2012 CODE DEVELOPMENT CYCLE

2012 FINAL ACTION AGENDA DISCUSSION GUIDE

**2012 ICC CODE DEVELOPMENT CYCLE
TECHNICAL UPDATES TO THE 2012 FINAL ACTION
AGENDA FOR THE PROPOSED CHANGES
TO THE:**

Updated 10/08/2012

S298-12

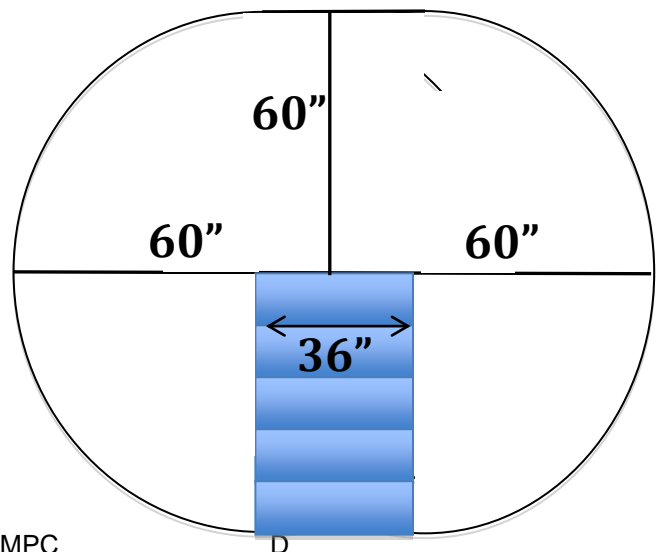
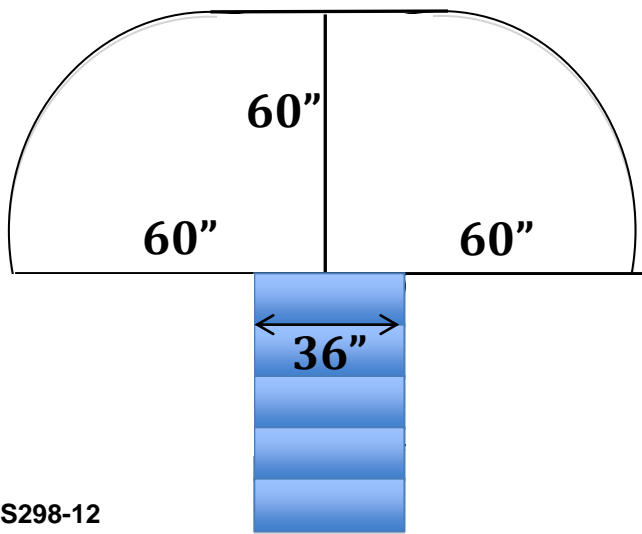
2406.4.7 Glazing adjacent to the bottom stair landing. Glazing adjacent to the landing at the bottom of a stairway where the glazing is less than 36 inches (914 mm) above the landing and within a 60 inch (1524 mm) horizontal arc less than 180 degrees from the bottom tread nosing shall be considered a hazardous location.

Committee Reason: This code change does not clarify the requirements for glazing adjacent to the bottom stair landing. The term arc is not necessary and an illustration in the reason could help clarify the intent of this revision.

Previous editions of the IBC before the 2012 required glazing that is 60” horizontally in any direction to be approved safety glazing. It is not clear why this requirement was changed in the 2012. The previous editions had the additional wording “in any direction” when applying the 60” horizontal rule. This is due to the “splay” factor for when someone gets to the last tread and falls. The tendency is for someone to flail out in any direction.

This added wording will make this section only apply to any glazing that is in a wall that is less than 180 degrees from the bottom tread nosing. I believe that adding the wording which would limit the area needing safety glazing to any glazing that falls within a 180 degree arc from bottom tread nosing and extending out 60” makes more sense since it is extremely unlikely that someone will fall out and backwards. I have added an illustration which should help everyone see what this changed wording will do.

The new code language will incorporate the areas shown on the left diagram while the current code language covers the areas on the right diagram.
